Access Compliance Report Public Rights-of-Way (Curb Ramps)

Main Street: E_FAIRHAVEN_AVE Cross Street: S_CEDARWOOD_ST Location: N

ADA ID: RPRK211007113724 Ramp Type: Type 1 - Perpendicular Diagonal Initial Pass/Fail: Fail Overall Compliance: No Severity Score: 2

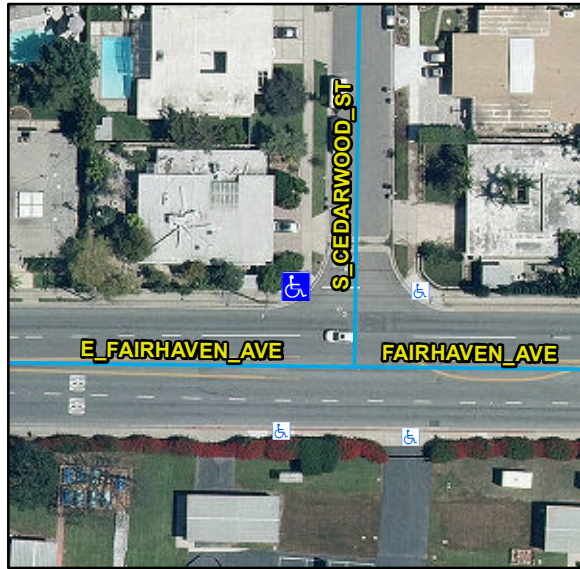
R304.2.2, R304.5.3, STD 1115

Remove & Replace Curb Ramp With Two New Directional Ramps or Equivalent.
